SERVICE BULLETIN

APPLICABILITY: 2014MY Forester Turbo

NUMBER: 02-152-14

SUBJECT: Revised Valve Train Parts to Reduce a Warm Engine
 Tapping Sound from the Left Cylinder Head

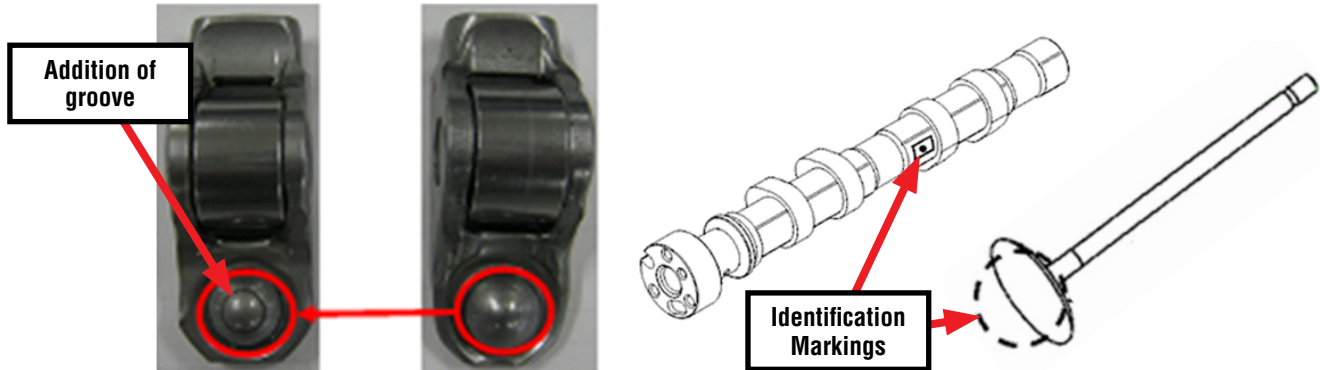
- Design change to the valve rockers
- Camshaft profile change
- 1.65mm longer intake and 2.45mm longer exhaust valve stem lengths
- Revised rocker pivots were incorporated at the start of 2014MY production

The illustrations below show additional information about the changes to the valve rockers, camshafts and valves to help readily distinguish them from the previous version parts.

PART NAME		NEW	OLD
INTAKE VALVE	Part Number	13201AA670	13201AA640
	Change	Stem Length:	Stem Length:
		104.95mm	103.3mm
Identification	I31	I22	
EXHAUST VALVE	Part Number	13202AA800	13202AA740
	Change	Stem Length:	Stem Length:
		97.9mm	95.45mm
Identification	E3B	E2B	
VALVE ROCKER	Part Number	13249AA250	13249AA240
	Change	Change to Roller Portion	n/a
	Identification	Circular groove added on pivot side	n/a
INTAKE CAMSHAFT, LEFT	Part Number	13037AA970	13037AA840
	Change	Cam Profile Change	n/a
	Identification	38B380	38B240

PART NAME		NEW	OLD
EXHAUST CAMSHAFT, LEFT	Part Number	13052AA970	13052AA840
	Change	Cam Profile Change	n/a
	Identification	53B380	53B240
